Access Compliance Report

Public Rights-of-Way

(Curb Ramps)

Intersection ID: 3177	Main Street: HUNTERS_WHIP_CT	Cross Street: SUTTERS_HILL_CT	Location:	N
ADA ID: 240AE9028FD1	Ramp Type: Perp	Initial Pass/Fail: Fail	Overall Compliance: No	Severity Score: 25
Codes/Mitigation Info/Possible Solution		Field Measurements/Component Compliance

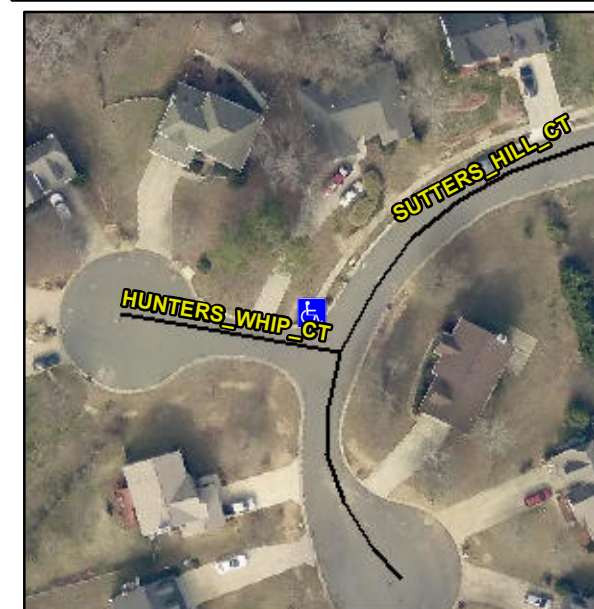
Not Found, R304.5.3

Compliance	Description	Data	Compliance	Description	Data
N/A	Ramp Length (in)	89.0	Yes	Ramp Slope (%)	6.0
Yes	Ramp Width (in)	58.5	No	Ramp XSlope (%)	9.6
N/A	Flare Type LT	N/A	N/A	Flare Type RT	N/A
N/A	Flare Slope LT (%)	N/A	N/A	Flare Slope RT (%)	N/A
N/A	Flare Traversable LT?	N/A	N/A	Flare Traversable RT?	N/A
N/A	Landing Length (in)	N/A	N/A	DWS Provided?	N/A
N/A	Landing Width (in)	N/A	N/A	DWS Contrast?	N/A
N/A	Landing Slope (%)	N/A	N/A	DWS Length (in)	N/A
N/A	Landing X Slope (%)	N/A	N/A	DWS Full Width?	N/A
N/A	Landing Curb? (Y/N)	N/A	N/A	DWS Offset (in)	N/A
N/A	Shared Landing?	N/A			
N/A	Gutter Ponding?	N/A	N/A	Gutter Slope (%)	N/A
N/A	Gutter Lip Ht (in)	N/A	N/A	Gutter X Slope (%)	N/A
N/A	Painted X Walk1?	No	N/A	Painted X Walk2?	N/A
	X Walk 1 Direction	To SW		X Walk 2 Direction	N/A
N/A	X Walk 1 Width (in)	N/A	N/A	X Walk 2 Width (in)	N/A
	X Walk 1 Slope (%)	1.7		X Walk 2 Slope (%)	N/A
	X Walk 1 X Slope (%)	3.8		X Walk 2 X Slope (%)	N/A

Remove & Replace Entire Ramp.
